# TOWN OF LOS GATOS

**PLAN CHECK COMMENTS**

**SCOPE OF WORK**  
• INTERIOR TENANT IMPROVEMENT (E) FOOD SERVICE REST.  
- DEMOLISH EXISTING FOOD SERVICE FACILITY  
- REPLACE MEZZANINE FLOOR  
- UPGRADE (E) FACILITIES TO COMPLY W/ HEALTH DEPT.  
- NO STRUCTURAL CHANGE - NO LIGHTING CHANGE W/ DINING RM  
• APPLICABLE CODES  
UPC, UMC, UPC 1994, NEC 1993  
ENERGY STANDARD 1995  
ACCESSIBILITY STANDARD  
CITY OF LOS GATOS REGULATIONS  
E-CODES.

PROPOSED TENANT IMPROVEMENT 151 N. SANTA CRUZ LOS GATOS - CA

Sheet 2

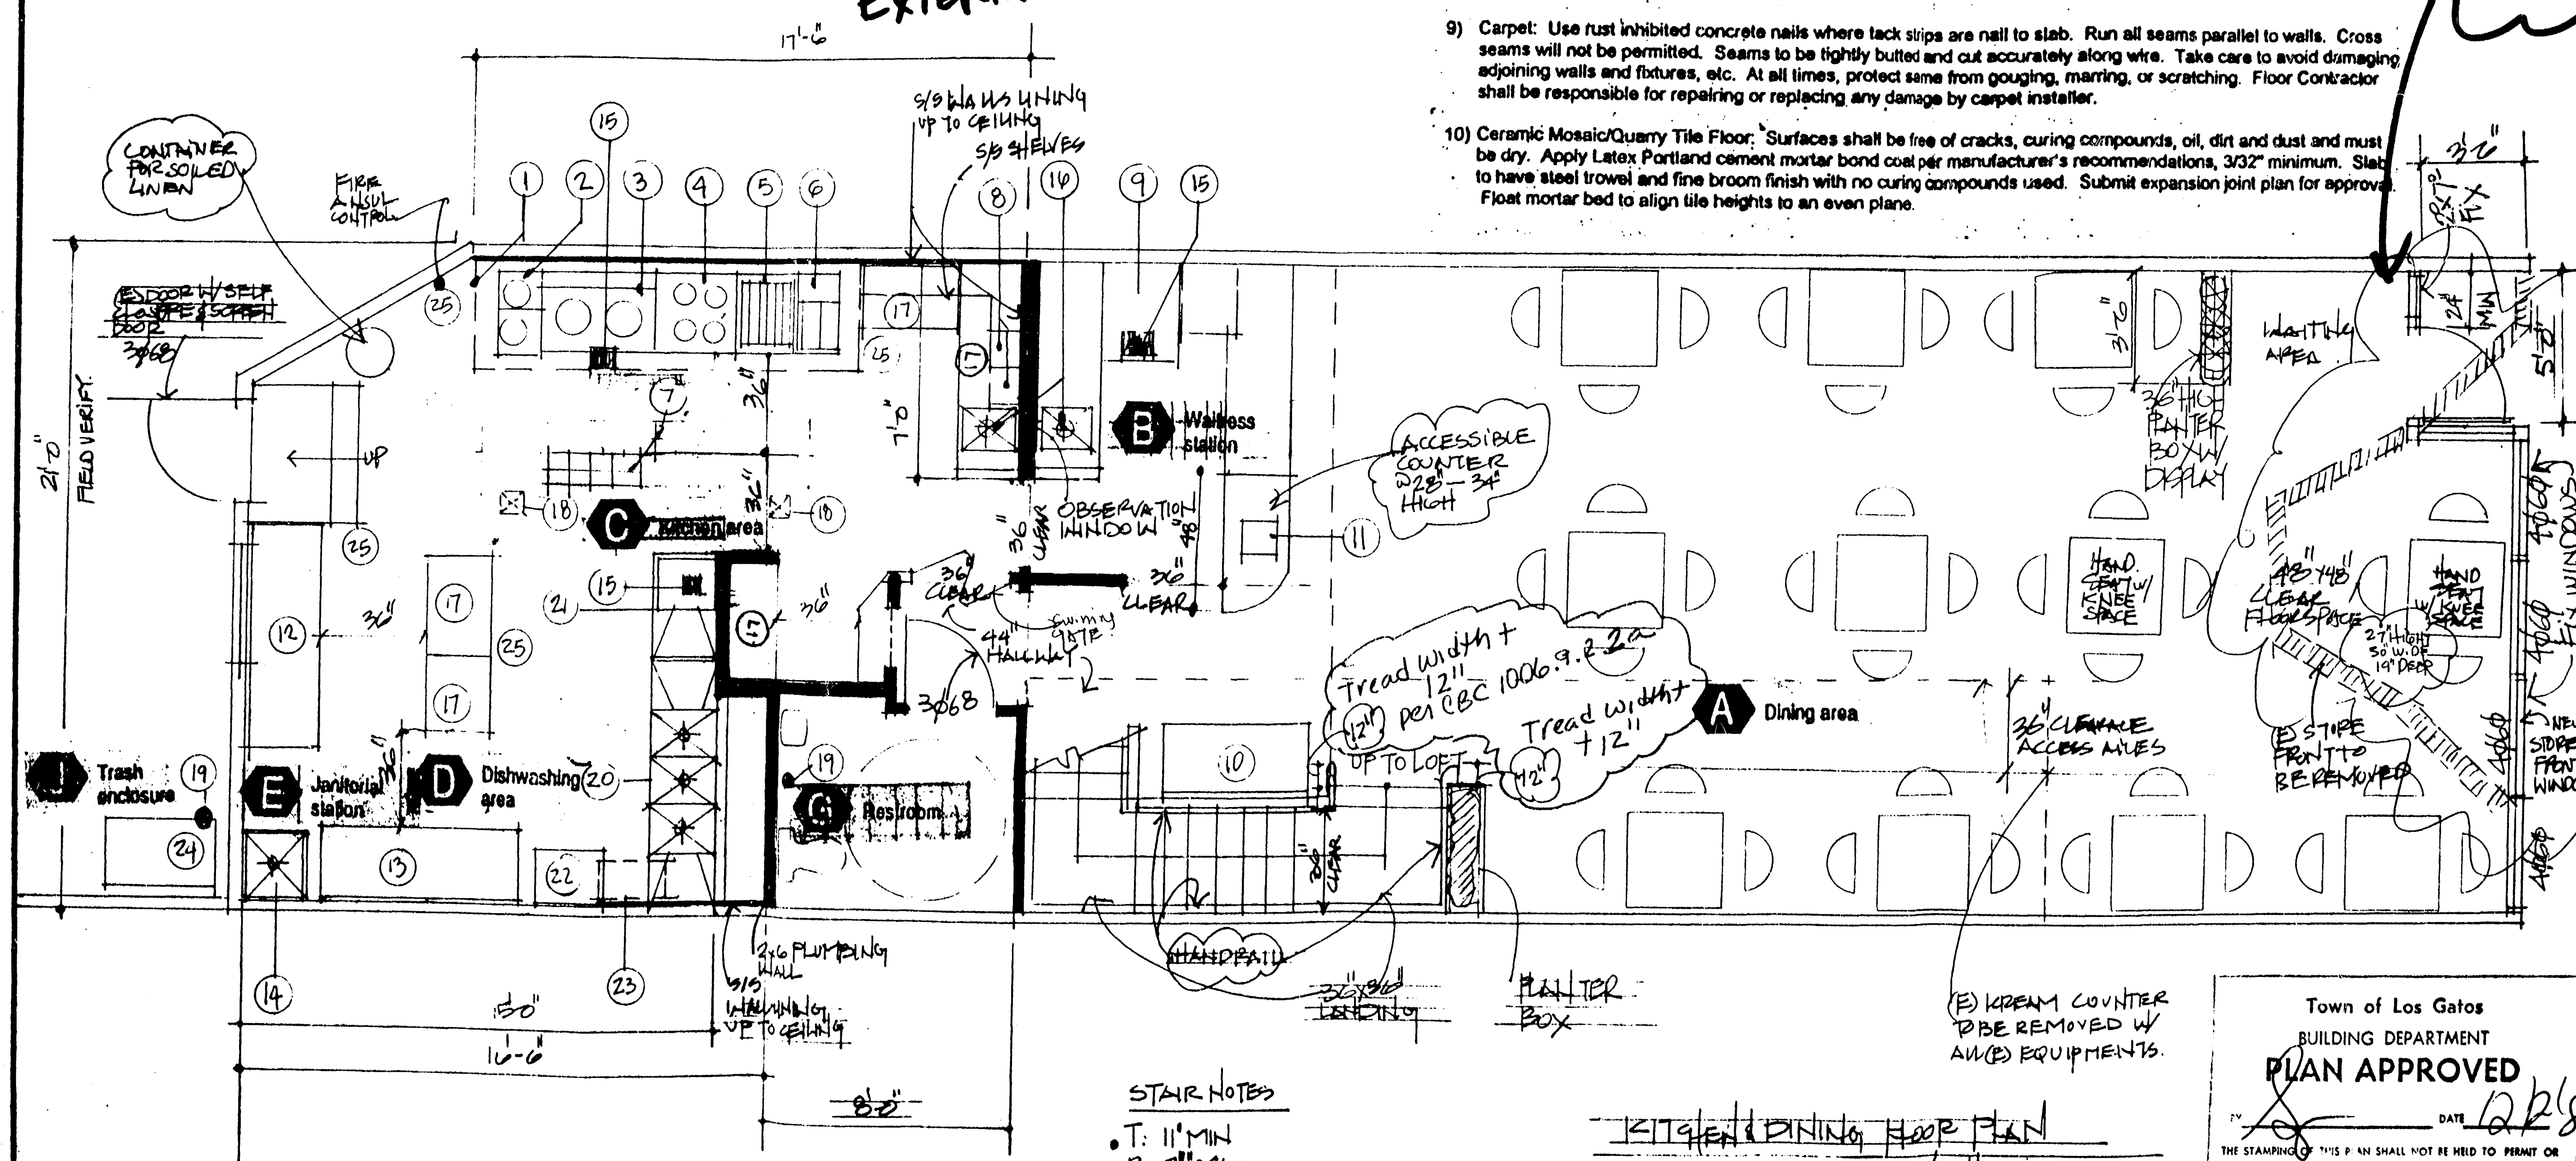
4. Label on the plans the sizes of the proposed store-front windows.
5. Provide a letter from the tenant indicating the total number of employees for the tenant space, as required per UBC Section 2902.3. If the tenant has more than 4 employees, revise the plans to show separate sanitary facilities (both of which will be required to be accessible), per CBC Section 1115B.2.

6. Revise the opening between the waitress station and the kitchen area to be minimum 36" wide and the opening between the waitress station and dining area at the counter to be minimum 36" wide, as required per CBC Section 1105B.3.2.

7. Revise the kitchen floor plan to provide minimum 36" clear access throughout, as required per CBC Section 1104B.5.8.
8. Revise the plans to show location of accessible seating (minimum 5% of total seating provided must be accessible) in the dining area, as required per CBC Section 1104B.5.4. Show the following clearances on the plans:

9. Revise the floor plan and the mezzanine plan to show handrails on both sides of the stairway, as required per CBC Section 1006.9.1a.
10. Revise the plans to show handrail extensions at the top and the bottom of the stairway, as required per CBC Section 1006.9.2a.

1. SHEET 7 - 12
2. SHEET 1
3. SHEET 2
4. SHEET 2
5. SHEET 2
6. SHEET 2
7. SHEET 2
8. SHEET 2
9. SHEET 2
10. SHEET 2-4
11. SHEET 5
12. SHEET 5
13. SHEET 5
14. SHEET 5 / SHEET 12
15. SHEET 5 / SHEET 12
